PRODUCT CHANGE | CU41 PANEL BAR END CAP + FIXING SCREW

DISCONTINUED PRODUCT	REPLACEMENT PRODUCT	CHANGES MADE	
			YES	NO
DESCRIPTION.	CU41 Panel Bar End Cap + Fixing Screw	CU41 Panel Bar End Cap + Fixing Screw	<input type="checkbox"/>	<input checked="" type="checkbox"/>
CODE.	CU41-0283-xxx000	CU41-0283-xxx000	<input type="checkbox"/>	<input checked="" type="checkbox"/>
PACK SIZE.	100 5000 SET	100 5000 SET	<input type="checkbox"/>	<input checked="" type="checkbox"/>
PRICE.	Log in to access pricing	Log in to access pricing	<input type="checkbox"/>	<input checked="" type="checkbox"/>
COLOUR / FINISH.	Black, Pure white, Silver Grey	Black, Pure white, Silver Grey	<input type="checkbox"/>	<input checked="" type="checkbox"/>
IMAGE.			<input checked="" type="checkbox"/>	<input type="checkbox"/>
USE WITH.	CU41 Panel Bar	CU41 Panel Bar	<input type="checkbox"/>	<input checked="" type="checkbox"/>
TRANSITIONING DATES	SILVER GREY – March 2022 (with non-magnetic screw) April 2022 (with magnetic screw) PURE WHITE – May 2022 BLACK – Jun 2022

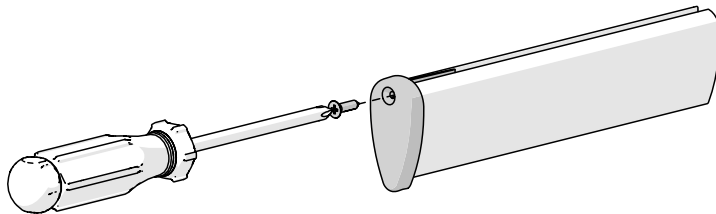
- CU41 Panel Bar End Cap has been modified for a looser fit onto Panel Bar allowing for faster assembly during manufacturing.
- Screw material updated to magnetise to screwdriver for faster assembly of end caps to panel bar.
